## (1) Comments from referees/public & Author's response

**Manuscript: amt-2023-106**

**Title: Aerosol properties derived from COCCON ground-based Fourier Transform spectra**

### **Response to Referee#1**

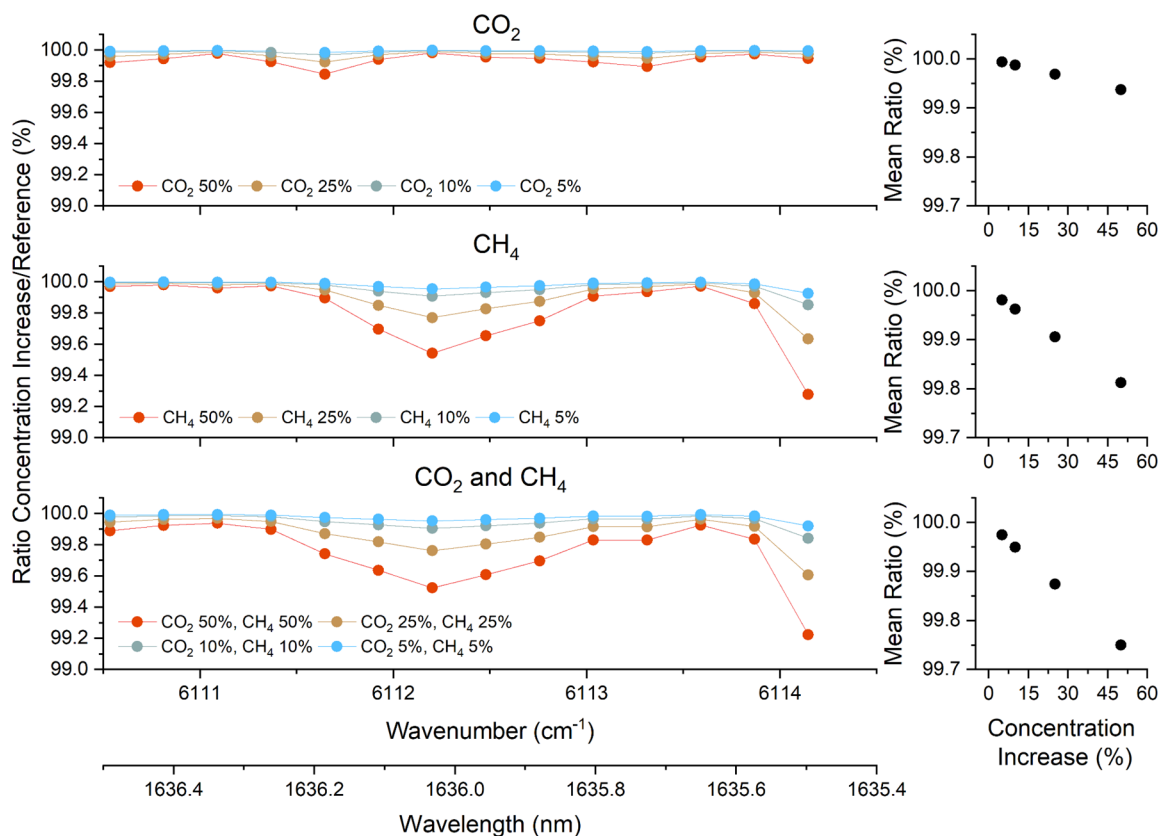
**2. AOD at 1640 nm needs a GHG correction. Is this already done and do you use actual FTIR GHG concentrations to do it?**

**Authors:** As stated in the manuscript, AOD values have been calculated following the AERONET procedures and the methodology proposed by Barreto et al. (2020). Utilizing the same approach as AERONET serves two purposes: firstly, it ensures the derivation of reliable AOD values due to the well-established and widely recognized nature of the AERONET methodology within the aerosol community; secondly, it enables a meaningful comparison between the new EM27/SUN AOD products and the AERONET reference AOD data.

Consequently, in this study, AOD at 1640 nm has indeed been adjusted for gaseous absorption through the use of the AERONET climatology correction. This correction is contingent upon the current Precipitable Water Vapor (PWV) content, while the quantities of carbon dioxide (CO<sub>2</sub>) and methane (CH<sub>4</sub>) are parameterized based on the present atmospheric pressure at the station (P) and at sea level (P<sub>o</sub>), following the methodologies outlined by Smirnov et al. (2004) and Giles et al. (2019), as detailed below:

Figure 1 presents a summary of the test results, illustrating the ratio between the simulated solar absorption spectrum using the WACCM-v7 CO<sub>2</sub> and CH<sub>4</sub> vertical concentration profiles as the baseline, and the simulated spectra for incremental increases of 5%, 10%, 25%, and 50% in the CO<sub>2</sub> profile (upper panel), 5%, 10%, 25%, and 50% in the CH<sub>4</sub> profile (middle panel), and 5%, 10%, 25%, and 50% in both the CO<sub>2</sub> and CH<sub>4</sub> profiles (lower panel). The subplots on the left depict the mean ratio within the spectral bands as a function of the concentration increments. Note that EM27/SUN AOD is estimated from the averaged solar absorption spectra in the micro-windows defined in Table 1 of the manuscript.

The most pronounced interference arises from CH<sub>4</sub>, resulting in a variation of 0.40% for the most extreme scenario (a 50% increase relative to the climatological value) at the center of the absorption line. This variation translates to a mere 0.20% mean ratio difference across the entire 1640 band. When considering the combined influence of CO<sub>2</sub> and CH<sub>4</sub> (lower panel of Figure 1), the intra-band variation remains limited to 0.25% for a 50% increase in CO<sub>2</sub> and CH<sub>4</sub> vertical concentration profiles. This estimation is a quite conservative estimation of the difference between utilizing a climatological approach like AERONET and utilizing actual gas concentration observations at the site.

Comparing the observed intra-band variations in the simulations with the intra-band coefficient of variation (CV) values derived from the measured solar absorption spectra within the 1640 band (0.67%, as depicted in Table 1 of the manuscript), we can deduce that the impact of CO<sub>2</sub> and CH<sub>4</sub> on AOD estimations is expected to be insignificant. Thus, the AERONET approach proves adequately precise for acquiring dependable AOD values. This assertion finds support in the uncertainties assessed through the Monte-Carlo method within this spectral band, as well as the minimal mean differences, standard deviations, and root-mean-squared errors observed in the CE318-AERONET and EM27/SUN comparison detailed in Section 5.4.

Figure 2. Comparison between the COCCON EM27/SUN and high-resolution (HR) IFS 125 retrievals for CO<sub>2</sub> and CH<sub>4</sub> at the Izaña Observatory. The HR IFS 125 observations are taken using the TCCON (TCCON HR12) and COCCON EM27/SUN measurement settings (EM27 HR125).

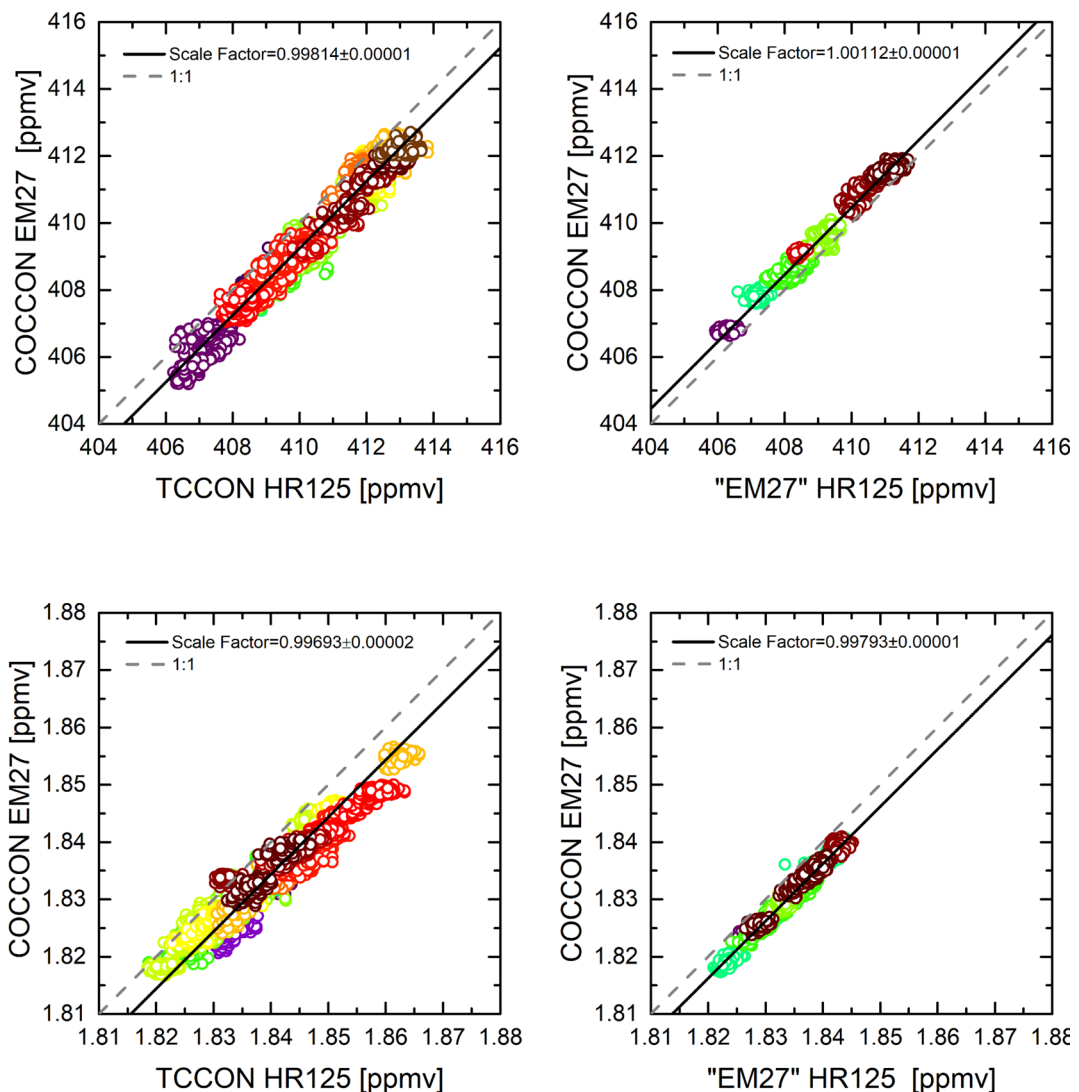
**5. Lines 131-132: Is there any further information about the uncertainty of the instrument or the performance according to the last calibrations available?**

**Authors:** According to the COCCON protocols (Frey et al., 2019; Alberti et al., 2022), to harmonize the retrieved species when using any COCCON spectrometer, empirical instrument-specific calibration factors for XCO<sub>2</sub>, XCO, XCH<sub>4</sub> and XH<sub>2</sub>O are calculated from the side-by-side

solar measurements with the COCCON reference spectrometer (SN37). The instruments are set up on the seventh floor at the Meteorology and Climate Research – Atmospheric Trace Gases and Remote Sensing (IMK-ASF) building located at KIT Campus North (49°050 38.7 00 N, 8°260 11.5 00 E, 134 m a.s.l.). The correction factors are calculated by comparing a defined gas retrieved with any EM27/SUN instrument with the reference instrument; a linear fit forced to zero intercept is performed, and then the slope is taken as its value.

The empirical calibration factors for XCO<sub>2</sub>, XCH<sub>4</sub>, XCO and XH<sub>2</sub>O for the IZO COCCON spectrometer (SN85) are presented in Alberti et al., (2022) and correspond to values lower than 0.999 for XCO<sub>2</sub>, XCH<sub>4</sub>, and XH<sub>2</sub>O, and lower than 0.980 for XCO (see Figure 24 or Table S2 in the Supplement of Alberti et al., 2022). In addition, the IZO COCCON instrument is continuously compared with the IZO TCCON IFS 125HR instrument, corroborating the calibration factors computed with respect to the COCCON reference (Figure 2).

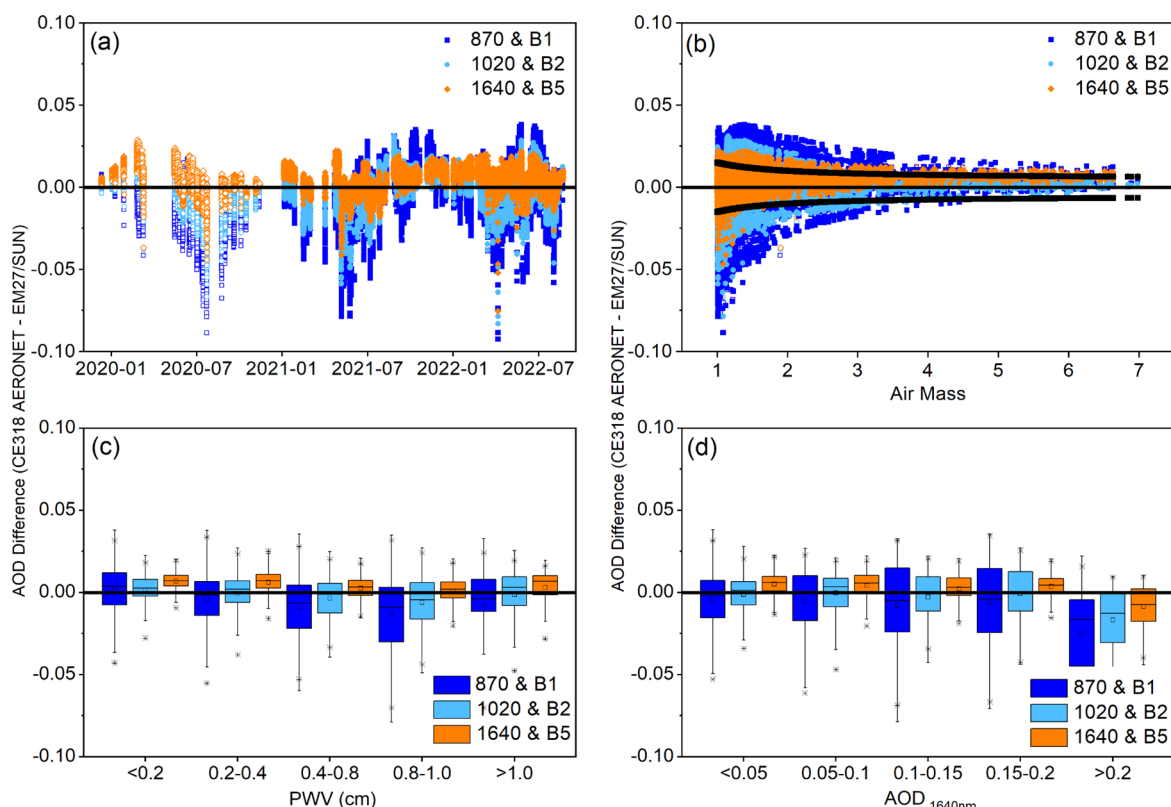
**12. Figure 5 (page 15): It is a bit puzzling why during the first period (2020 – 2021) the uncertainty is higher than the second one. Is it a matter of calibration?**

**13. Figure 6 (page 16): I would recommend to be presented in Section 5.4, probably after line 346.**

**Authors:** The period showing the highest AOD differences, as depicted in Figure 5, is the 2019-2020 timeframe. Initially, this behaviour was attributed to inadequately conditioned smoothing spline functions resulting from the absence of calibration during the 6-month period. Although this explanation seemed plausible, subsequent detection and rectification of a computational error have revealed only minimal discrepancies in AOD differences during this particular time span. These findings are presented in the revised figures and tables. Corresponding adjustments have been made to the text and tables accordingly.

All figures have undergone correction, with the exception of Figure 1 and the former Figure 7, now Figure 8. The good agreement observed between the AOD retrieved from CE318-AERONET and EM27/SUN in the new Figure 6 (former Figure 5, placed below) over this specific period, despite the gap of 6 months in the calibration due to COVID restrictions, has ensured the robustness of our calibration approach.

**Authors:** Figure 6 has been located at the end of Section 5.4 following the referee's suggestion.

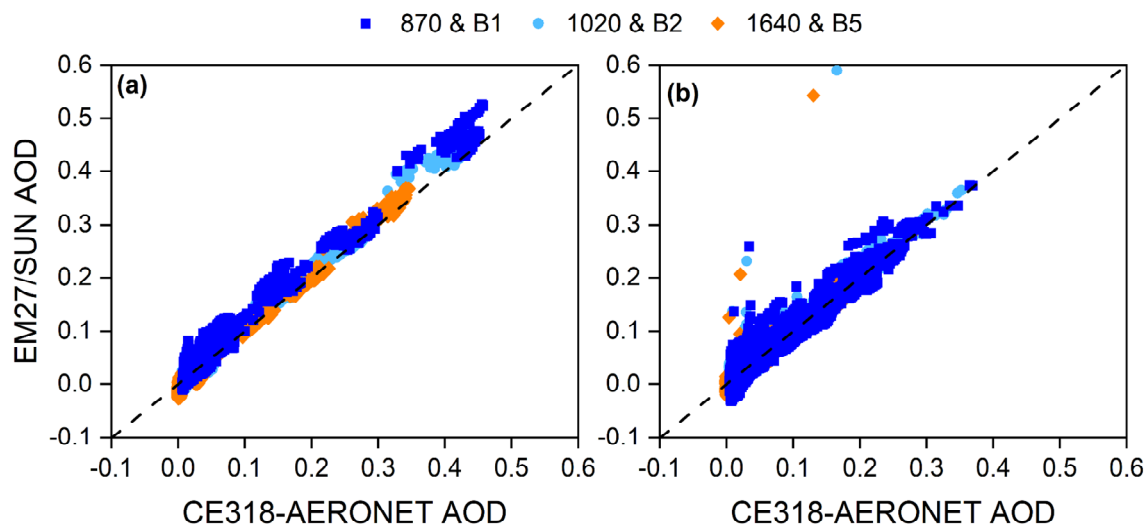
8.1. please make two figures, one with 2019-2022 (whole period) and the other one with Dec 2019 - Dec 2020, with the open markers and the plain one, it is too confusing to interpret the graphic.

8.2. In the legend "open circles" -> "open markers" (there are other open symbols than circles)

**Authors:** The authors agree with this comment. A Figure 4 has been replaced by this figure:

**Authors:** This statement has been modified in the manuscript following the referee’s suggestion.
